# Access Compliance Report

### (Curb Ramps)

Intersection ID: 20377	Main Street: MORVEN_LN	Cross Street: WINGRAVE_DR	Location:	N
ADA ID: 6E6306AF232D	Ramp Type: PerpDiag	Initial Pass/Fail: Fail	Overall Compliance: No	Severity Score: 21.25
Codes/Mitigation Info/Possible Solution		Field Measurements/Component Compliance

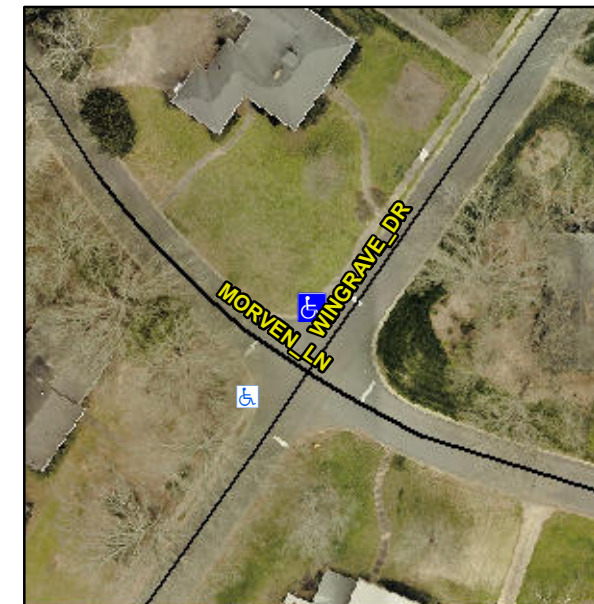
**Not Found, R304.5.1, R304.5.3**

Compliance	Description	Data	Compliance	Description	Data
N/A	Ramp Length (in)	55.0	Yes	Ramp Slope (%)	7.4
No	Ramp Width (in)	47.5	No	Ramp XSlope (%)	5.3
N/A	Flare Type LT	N/A	N/A	Flare Type RT	N/A
N/A	Flare Slope LT (%)	N/A	N/A	Flare Slope RT (%)	N/A
N/A	Flare Traversable LT?	N/A	N/A	Flare Traversable RT?	N/A
N/A	Landing Length (in)	N/A	N/A	DWS Provided?	N/A
N/A	Landing Width (in)	N/A	N/A	DWS Contrast?	N/A
N/A	Landing Slope (%)	N/A	N/A	DWS Length (in)	N/A
N/A	Landing X Slope (%)	N/A	N/A	DWS Full Width?	N/A
N/A	Landing Curb? (Y/N)	N/A	N/A	DWS Offset (in)	N/A
N/A	Shared Landing?	N/A			
N/A	Gutter Ponding?	N/A	N/A	Gutter Slope (%)	N/A
N/A	Gutter Lip Ht (in)	N/A	N/A	Gutter X Slope (%)	N/A
N/A	Painted X Walk1?	No	N/A	Painted X Walk2?	No
	X Walk 1 Direction	To SW		X Walk 2 Direction	To SE
N/A	X Walk 1 Width (in)	N/A	N/A	X Walk 2 Width (in)	N/A
	X Walk 1 Slope (%)	4.3		X Walk 2 Slope (%)	1.1
	X Walk 1 X Slope (%)	2.6		X Walk 2 X Slope (%)	3.6

**Remove & Replace Curb Ramp With Two New Directional Ramps or Equivalent.**
